Project	<b>IEEE 802.16 Broadband Wireless Access Working Group</b> < <a href="http://ieee802.org/16">http://ieee802.org/16</a> >	
Title	<b>Figure Change</b>	
Date Submitted	<b>2007-01-12</b>	
Source(s)	Peretz Feder Alcatel-Lucent Philip Barber Huawei	<a href="mailto:pfeder@alcatel-lucent.com">pfeder@alcatel-lucent.com</a> , <a href="mailto:pbarber@huawei.com">pbarber@huawei.com</a>
Re:		
Abstract	Changes to Figure F7	
Purpose	Adoption	
Notice	This document has been prepared to assist IEEE 802.16. It is offered as a basis for discussion and is not binding on the contributing individual(s) or organization(s). The material in this document is subject to change in form and content after further study. The contributor(s) reserve(s) the right to add, amend or withdraw material contained herein.	
Release	The contributor grants a free, irrevocable license to the IEEE to incorporate material contained in this contribution, and any modifications thereof, in the creation of an IEEE Standards publication; to copyright in the IEEE's name any IEEE Standards publication even though it may include portions of this contribution; and at the IEEE's sole discretion to permit others to reproduce in who

**Figure F7 – End-to-End Mobile Initiated HO exchange between MS, Serving BS and Target BS**

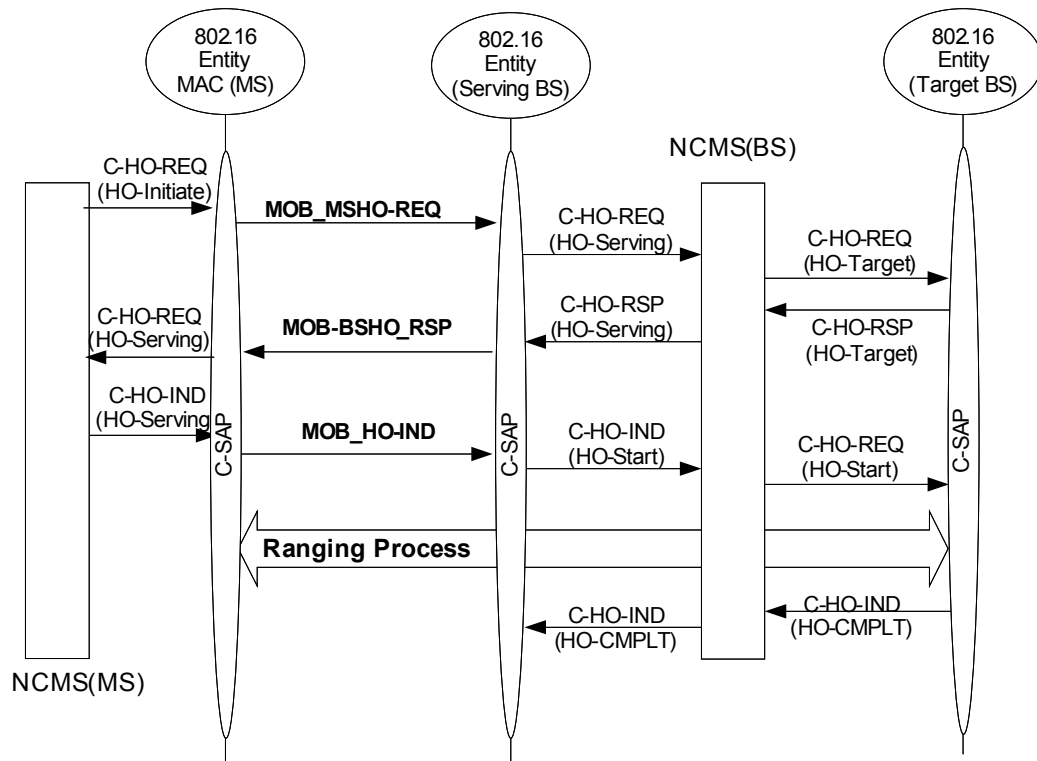
3 Update Figure F7 to include trigger for MOB\_MSHO\_REQ and MOB\_BSHO\_RSP  
4 primitives
